Application 10/501031

Response to Office Action dated 01/19/2007

**Amendments to the Drawings:**

Inventor: NAKANO  
Docket No.: 8279.758USWO  
Title: EMULSIFICATION/DISPERSION SYSTEM USING MULTISTAGE  
DEPRESSURIZATION MODULE AND METHOD FOR PRODUCING  
EMULSIFIED/DISPERSED LIQUID  
Attorney Name: Curtis B. Hamre  
Phone No 612-455-3802  
Sheet 3 of 13

**Fig.3**

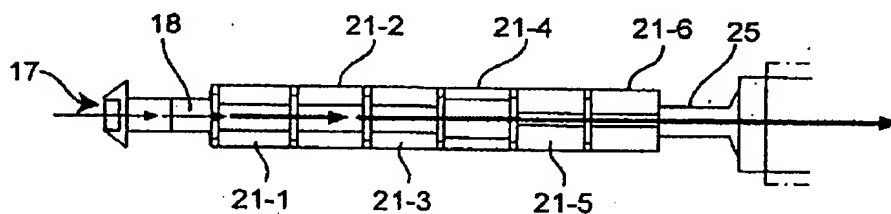
The attached sheets of drawings include changes to Fig. 3 and to Fig. 14. The first sheet, which includes Fig. 3, Fig. 5 and Fig. 8, replaces the original sheet including Fig. 3, Fig. 5 and Fig. 8. In Figure 3 the title has been changed from MULTISTAGE DEPRESSURIZATION MODULE to MULTISTAGE EMULSIFICATION/ DISPERSION MODULE. The second sheet, which includes Fig. 14, replaces the original sheet including Fig. 14. In Figure 14, reference numeral 480 has been changed to 400.

MULTISTAGE EMULSIFICATION/DISPERSION MODULE  
~~MULTISTAGE DEPRESSURIZATION MODULE~~
